City of Littleton

Meeting Agenda Historical Preservation Board

- a. [HPB Reso 04-2017](#) Resolution to approve a COA for new development at 2679 W. Main Street

Presented By: Andrea Mimnaugh, AICP, Principal Planner
--

LANDSCAPE PLAN

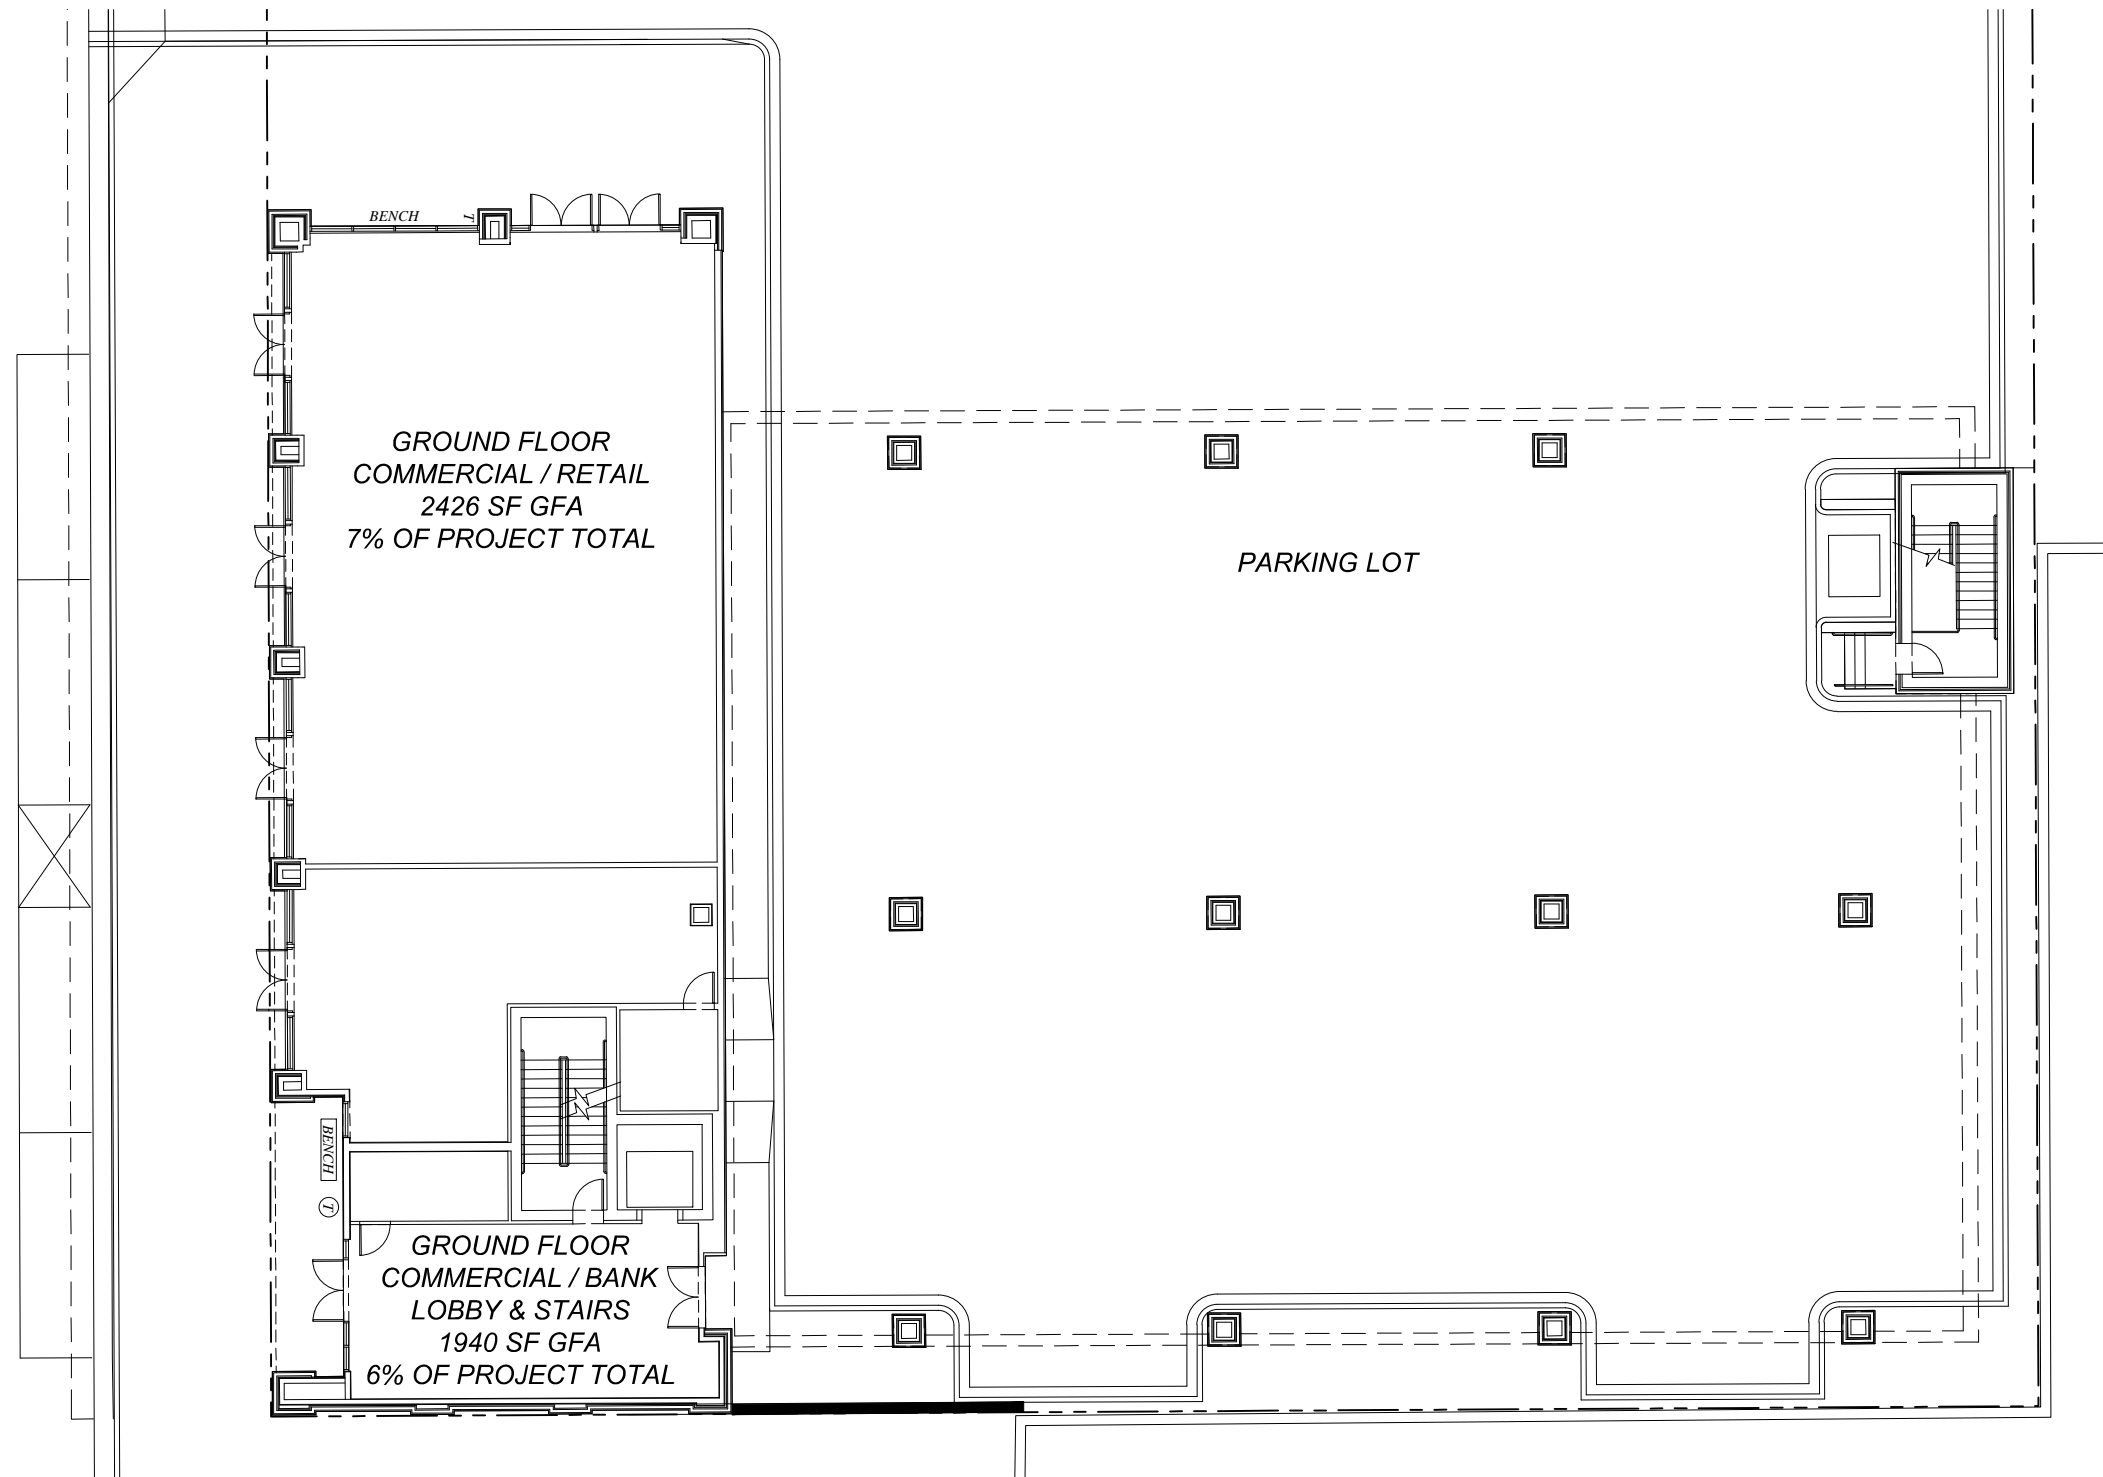
Applicant response: Nine percent of the open parking area is provided as landscape area and 75 percent of that area includes living plant material.

Staff analysis: This standard appears to be met, as described by the applicant in the above statement and as reflected in the COA plan set.

FIRST FLOOR STOREFRONT
WEST ELEVATION (1/4" = 1'-0")

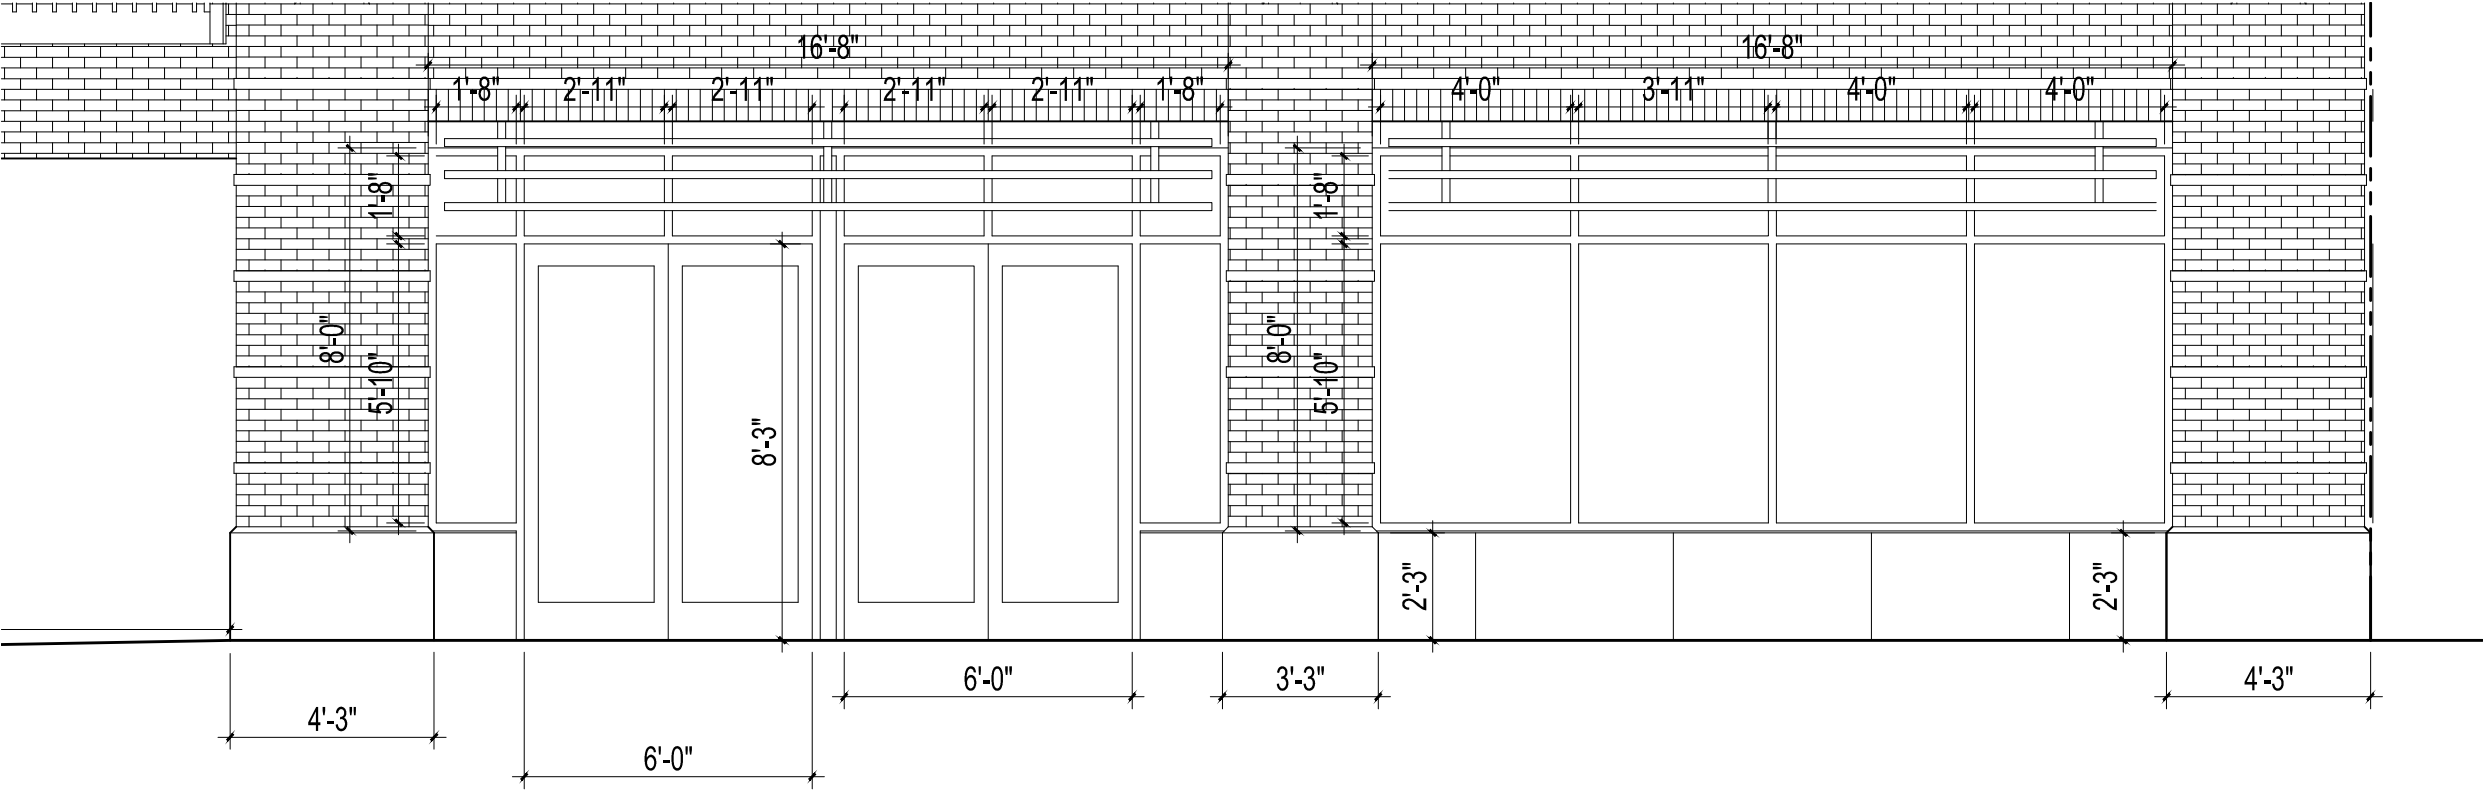
Applicant response: The proposed recessed entries are relatively shallow; 18” at the retail storefronts and 7’ at the office lobby entry. Neither of these recessed entries are deep enough to allow for an arcade.

Staff analysis: The ground floor retail bays are proposed to be 18” deep, which should provide visual interest without diminishing the visibility of the storefront windows. The building has a clearly identifiable front door that faces Main Street. The main entry is wider and deeper than the entries for the ground floor retail and has been designed to accommodate a prominent sign. The applicant has worked with city staff on recessed entrances as a mechanism for delineating individual storefronts and strengthening the rhythm of the building façade. The street-level entrance to the upper floors opens to both the Main Street sidewalk and to the interior parking. This standard appears to be met.

THIRD FLOOR DOORS, WINDOWS, BALCONY
AND VISORS ALONG MAIN STREET (1/8" = 1'-0")

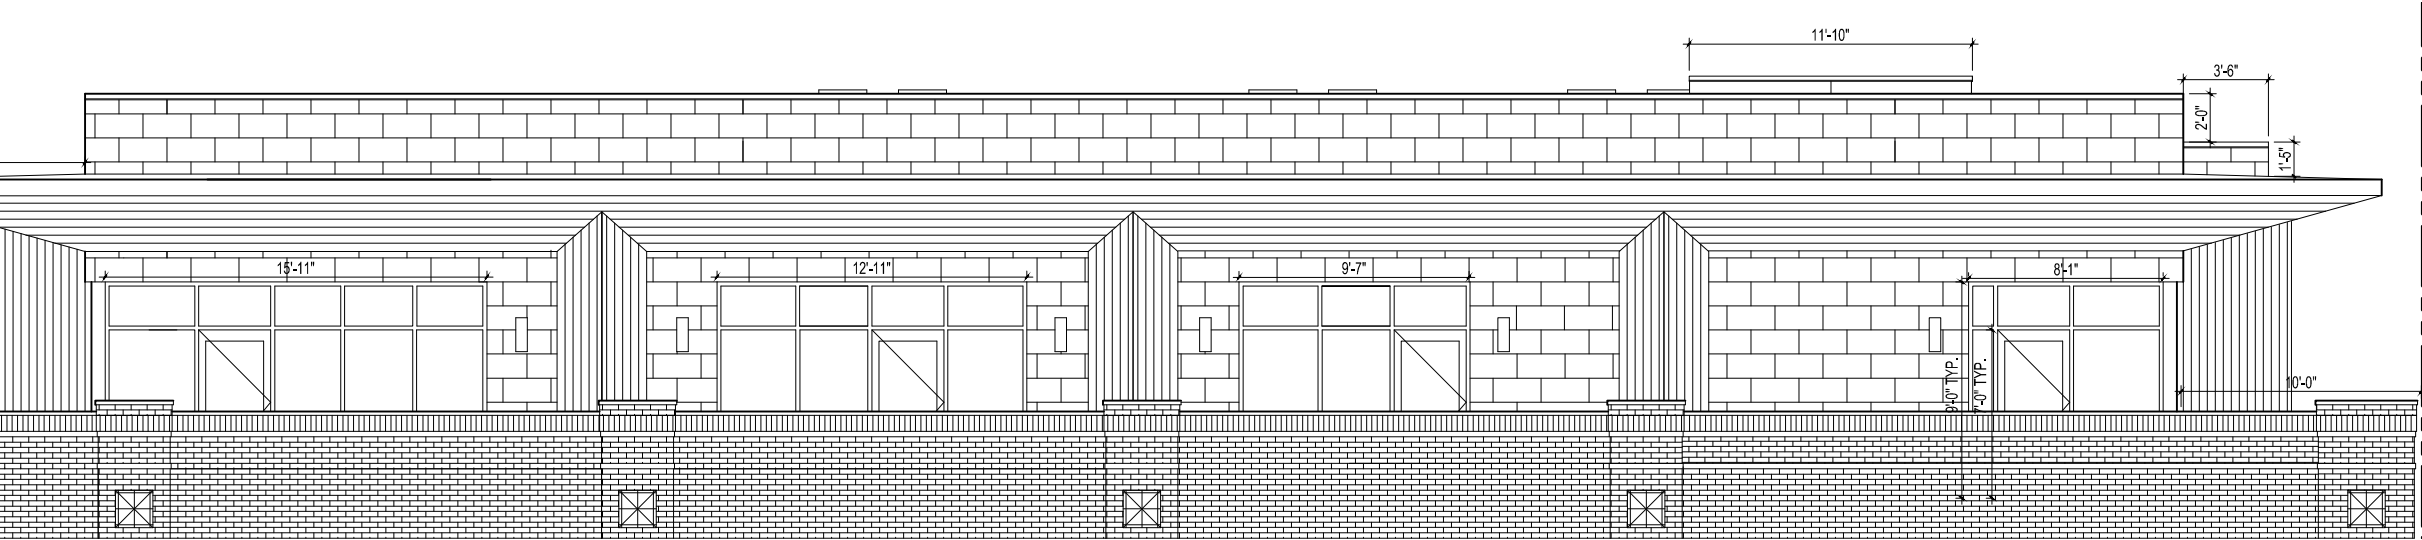
Applicant response: The third story of the building is stepped back from Main Street so that only 25 percent of the façade is visible from across the street, including the proposed cedar canopy.

Staff analysis: The third-story step back requirement is reflected on the COA plan set. This standard appears to be met.
